Amendments to the Drawings

REMARKS

Annotated
Marked-up Drawing

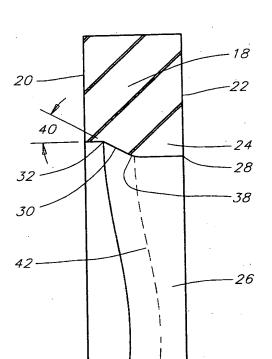
The drawings are objected to under 37 CFR 1.83(a) because the claimed features of the sealed partition, lubricant chamber, and hydrodynamic wedging angle must be shown in the drawings or canceled from the claims.

Added reference number 122 to indicate the lubricant chamber (See Appln, amended paragraph 58) and designation of the hydrodynamic wedging angle 158.

Applicants have amended drawing sheet 1 to accurately correspond to the specification. Fig. 1 has been amended to include reference number 122 for the lubricant chamber and designation of the hydrodynamic wedging angle 158. Applicant submits a marked-up copy of drawing sheet 1 labeled as "Annotated Marked-up Drawing" and a replacement sheet labeled as "Replacement Sheet." Applicant submits that no new matter has been introduced.
